ADDENDUM NO. KB - 03

**NEWINGTON TRANSITION ACADEMY &
OFFICES RELOCATION**
NEWINGTON TOWN HALL
NEWINGTON, CT
KBA #11004.00

Date: March 28, 2011
Page: 1 of 4

DATE: 03-25-2011	DRAWN: JLJ	DRAWING NO.:
SCALE: 1/8"=1'-0"	PROJECT NO.: 07047.04	SKFP-3.02

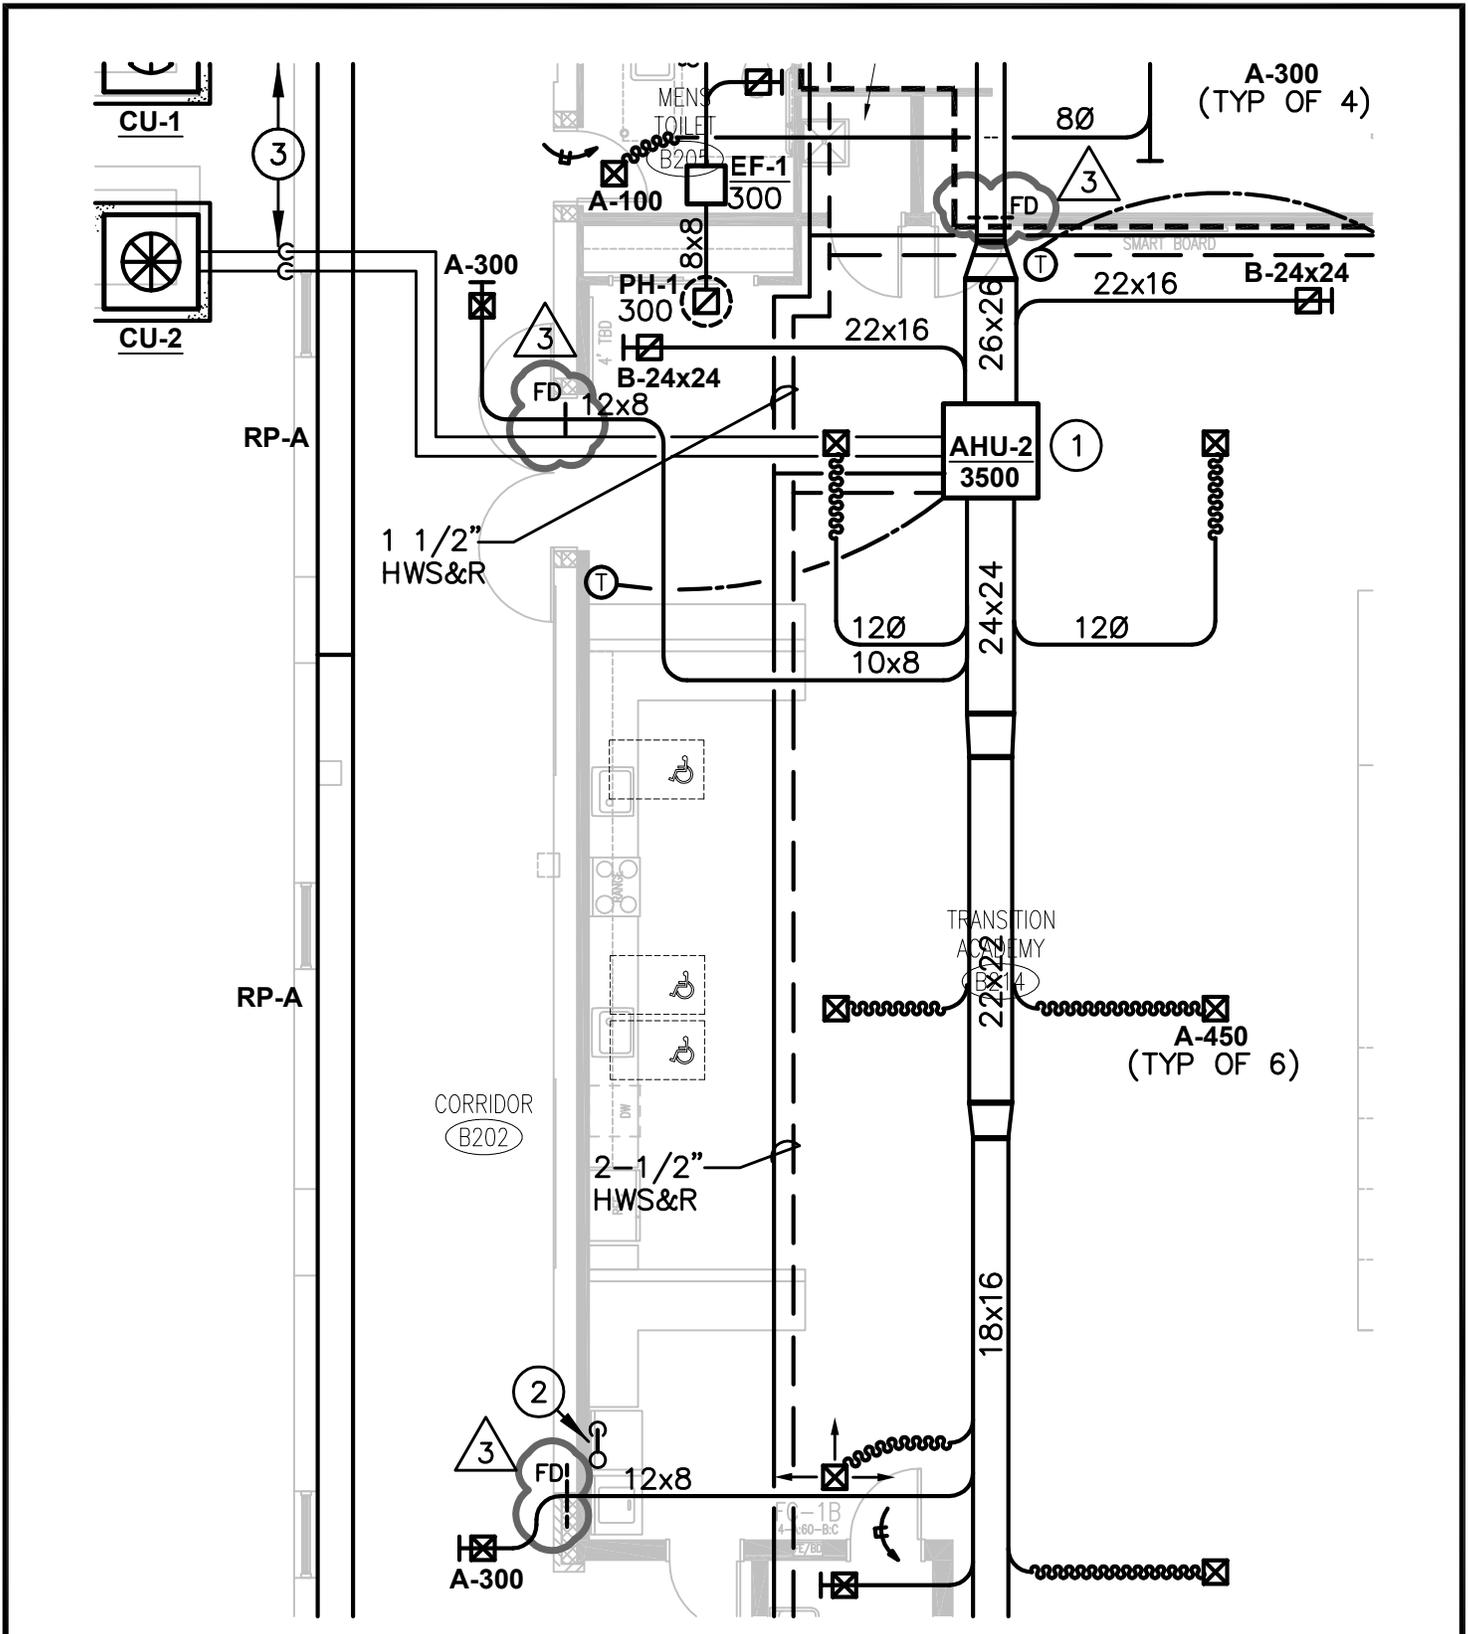
TITLE: EAST WING - MAIN LEVEL
FIRE PROTECTION REVISIONS

DRAWING NO.: SKH-3.01

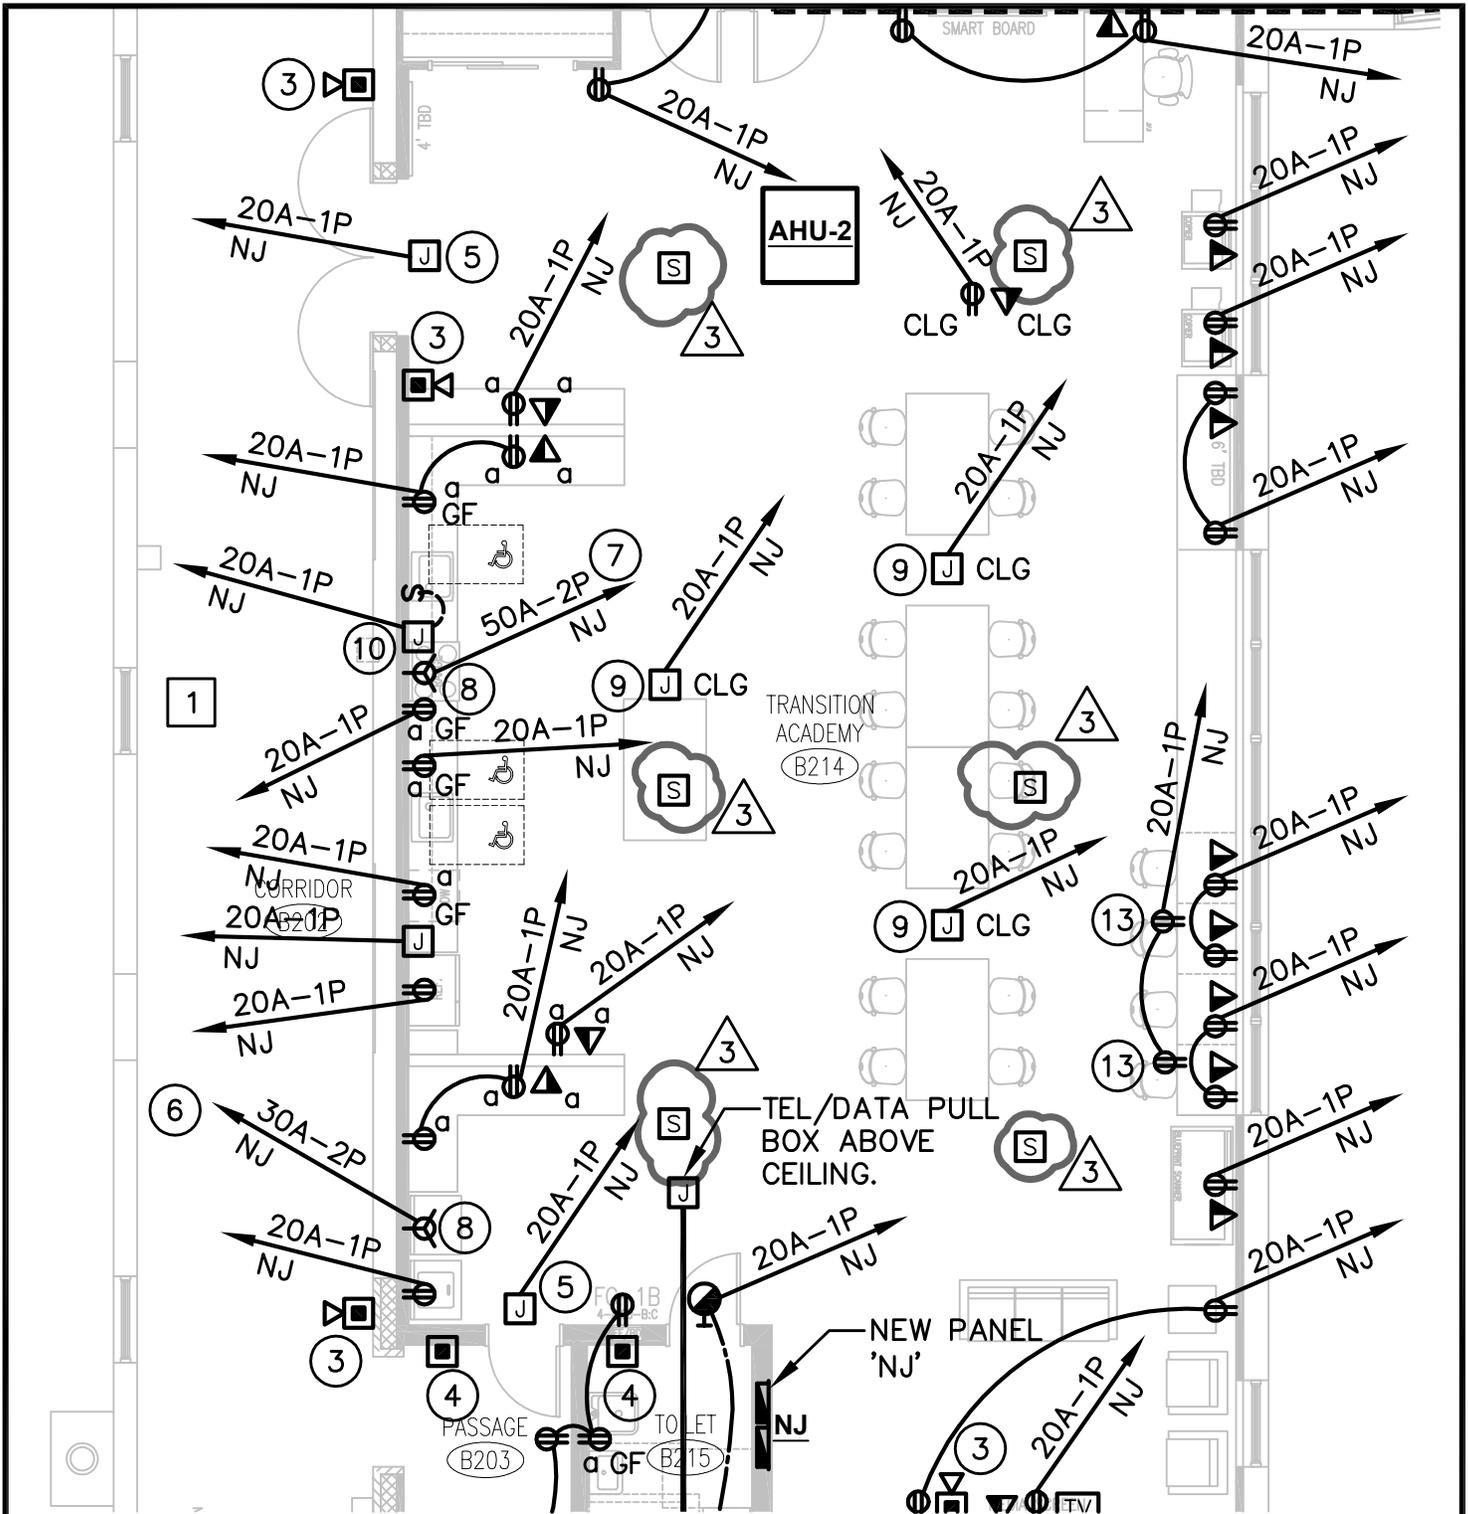
TITLE: EAST WING - UPPER LEVEL
HVAC REVISIONS

DRAWING NO.:
SKE-3.01

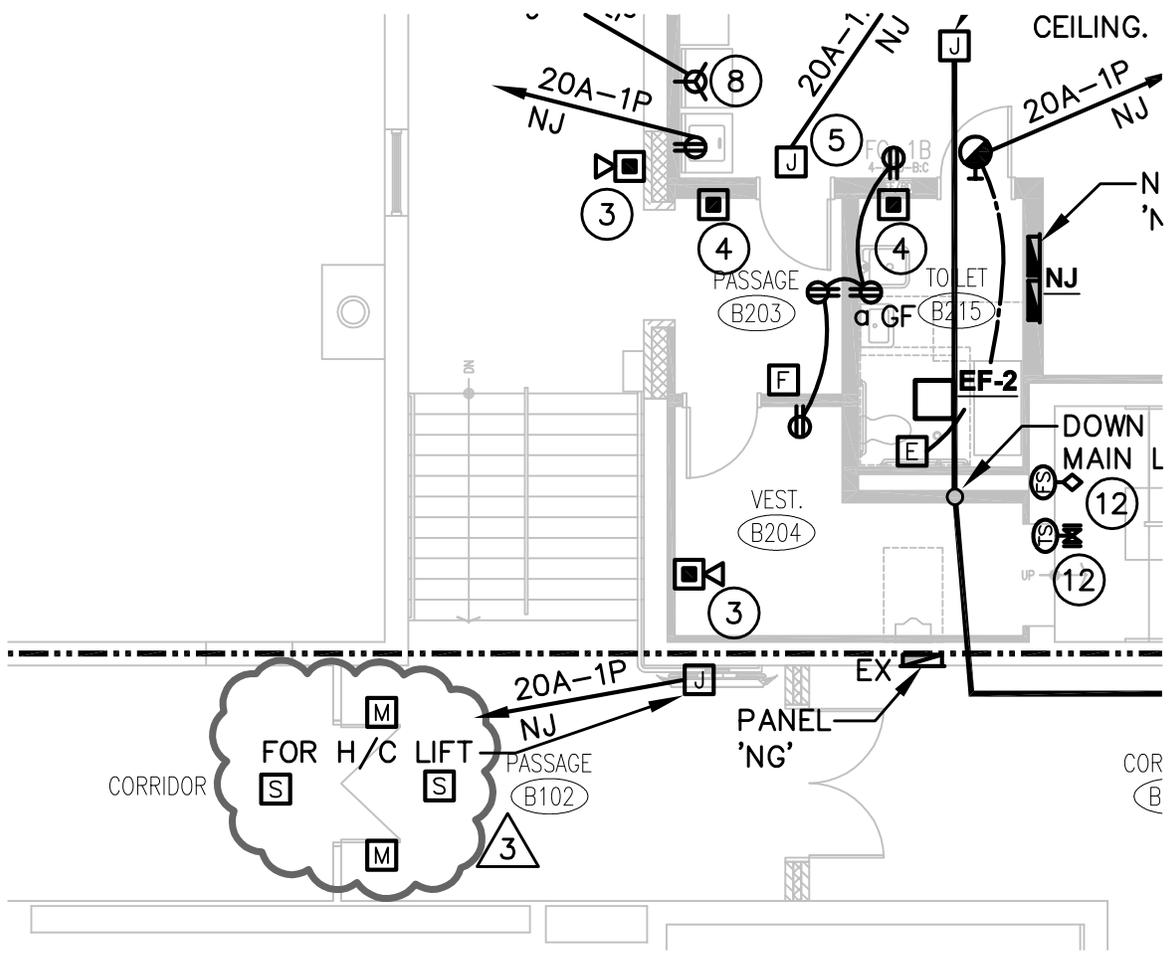
TITLE: EAST WING - UPPER LEVEL
 ELECTRICAL POWER REVISIONS

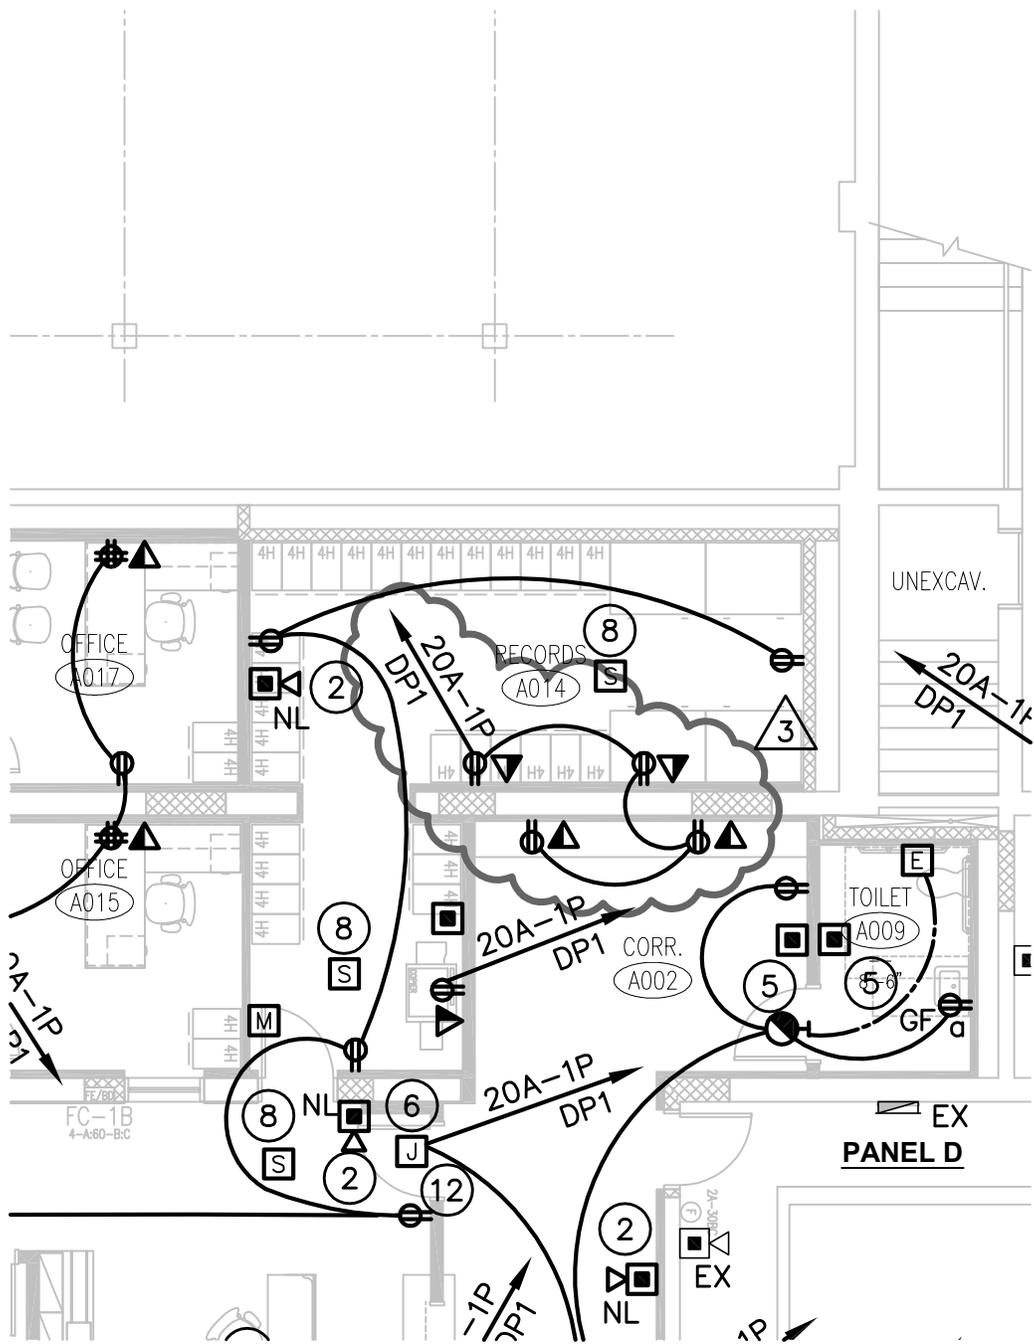
THIS SKETCH TO BE READ IN CONJUNCTION WITH THE CONTRACT DOCUMENTS	SKETCH GENERATED FOR:				
	ADDENDUM #3	R.R.F.I.	AS.I.	P.R.	C.C.D.
	REFERENCE DETAIL/SHEET: FP1.02				
TITLE: EAST WING - UPPER LEVEL ELECTRICAL POWER REVISIONS					
DATE: 03-25-2011	DRAWN: JLJ		DRAWING NO.:		
SCALE: 1/8"=1'-0"	PROJECT NO.: 07047.04		SKE-3.02
